# Amphenol Taiwan Corporation

## Product Change Notification

<b>Part Numbers Concerned :</b>	G861ABXXX1TS5HR	<b>Originator:</b>	Sandy Wu
<b>Product Description:</b>	G861 SERIES, WAFER 2.54 PITCH, STRAIGHT PCB MOUNT, W/CAP	<b>Issue Date:</b>	2021/10/15
		<b>PCN NO:</b>	1210-21001207
<b>Distribution:</b>	REMOVE 08-12P, ADD DIM,PLATING OPTION AND SOLDER AREA INFORMATION.

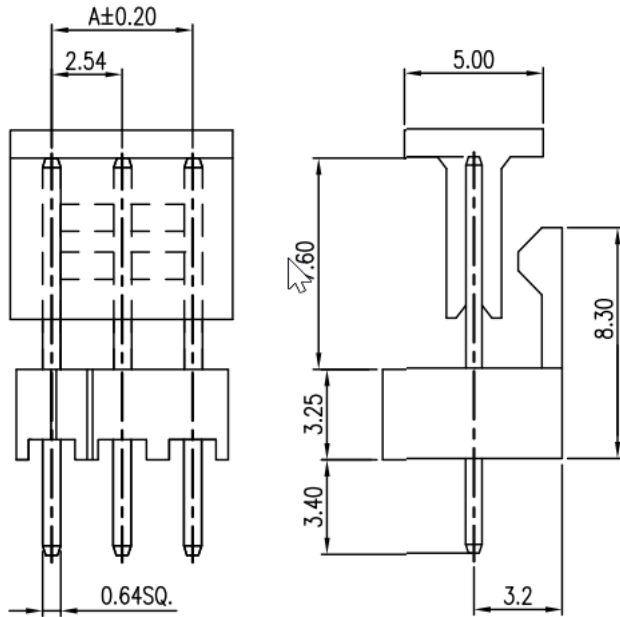
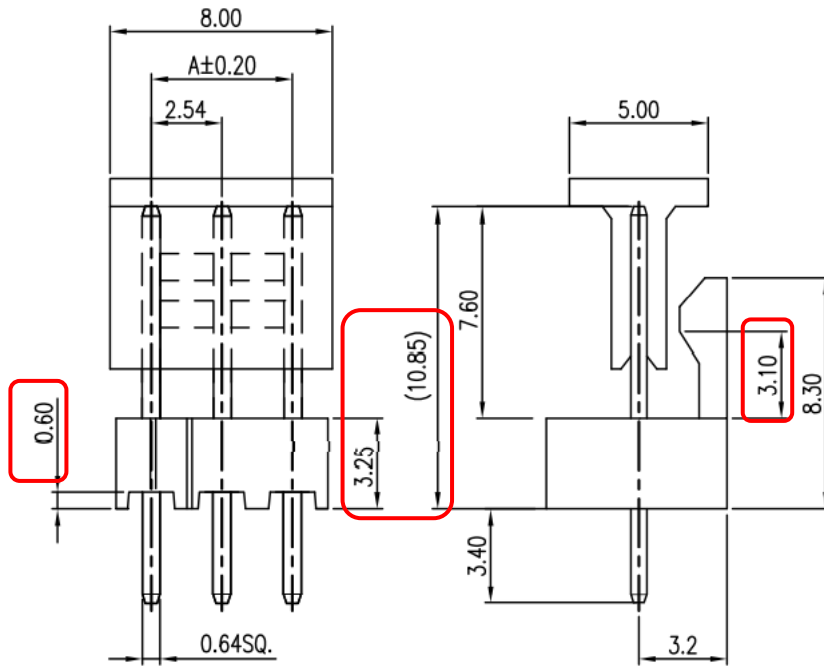
- This notification is to inform customers that part G861ABXXX1TS5HR for REMOVE 08-12P, ADD DIM,PLATING OPTION AND SOLDER AREA INFORMATION.

CONTACT FINISH/SOLDER AREA  
1: 100 $\mu$ m MATTE TIN/100 $\mu$ m MATTE TIN  
2: GOLD FLASH/GOLD FLASH  
3: 15 $\mu$ m GOLD/15 $\mu$ m GOLD  
4: 30 $\mu$ m GOLD/30 $\mu$ m GOLD
